Final Drainage Report
for
“Town of Monument Water Tank Site”

744 Forest View Way
Town of Monument, Colorado, 80132

PCD File Number - PPR-21-030

January 10, 2022

EXISTING DRAINAGE PLAN

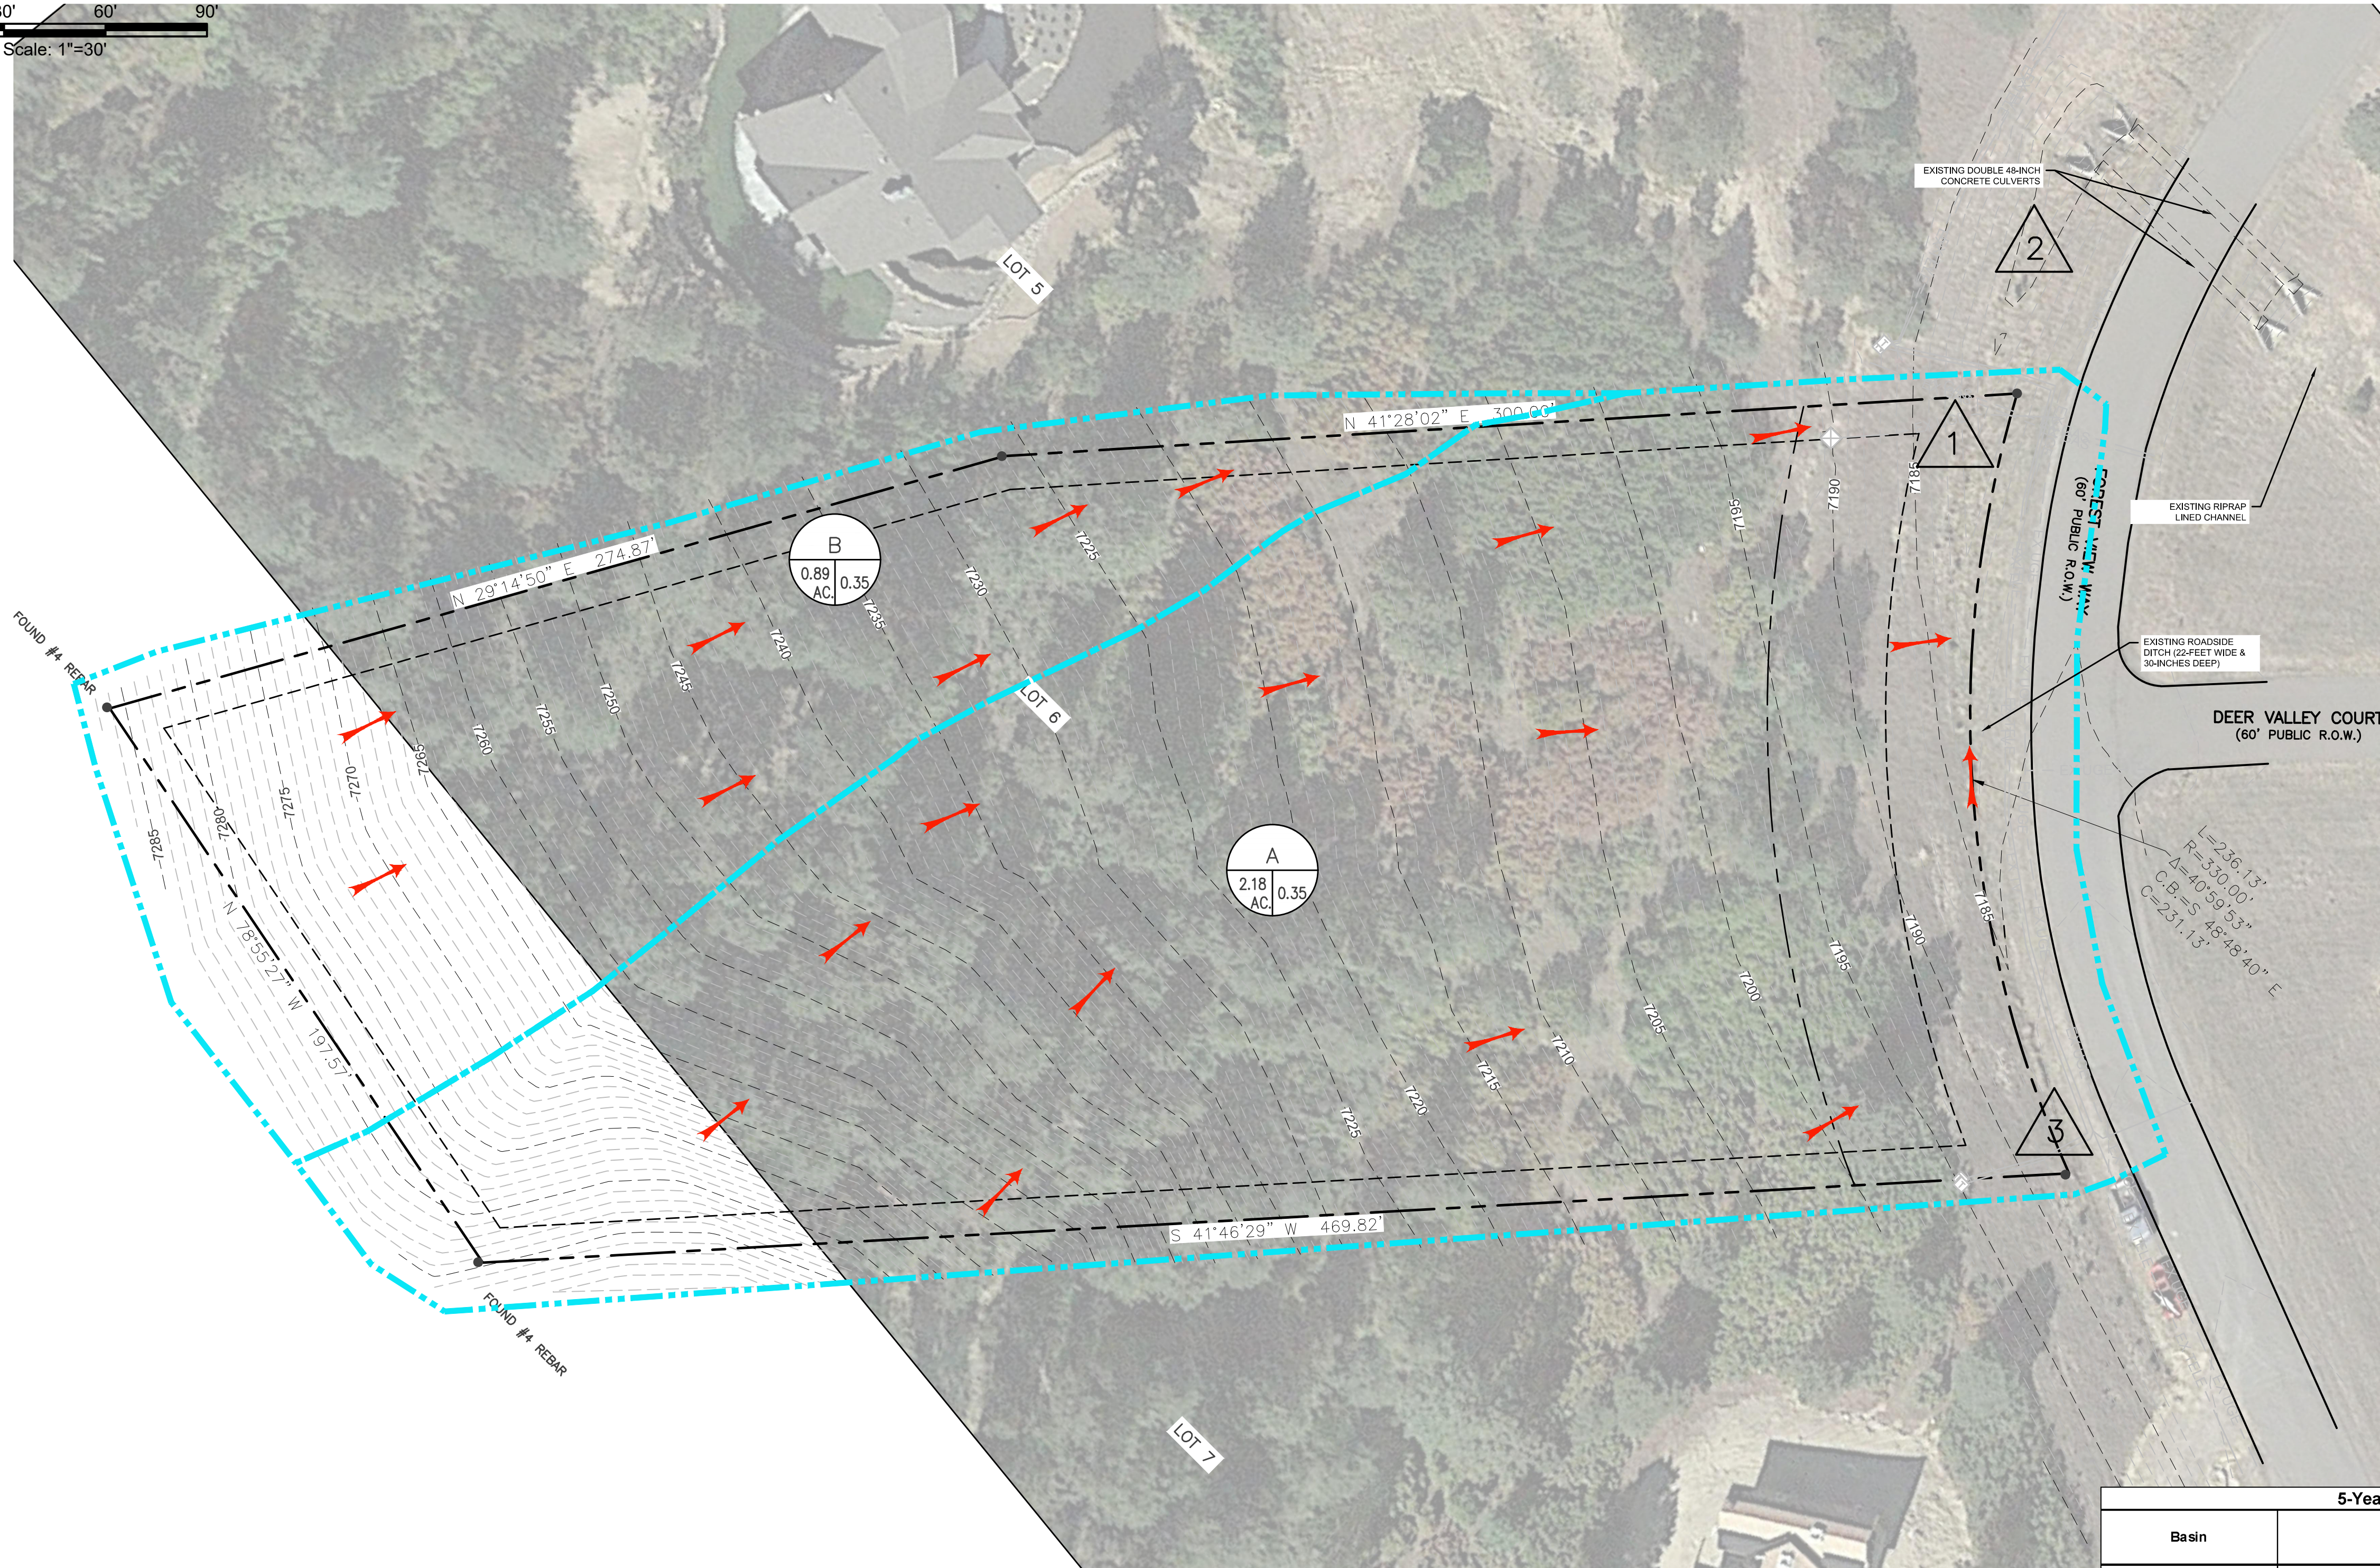
Unresolved. Please move drainage maps to end of report contents.
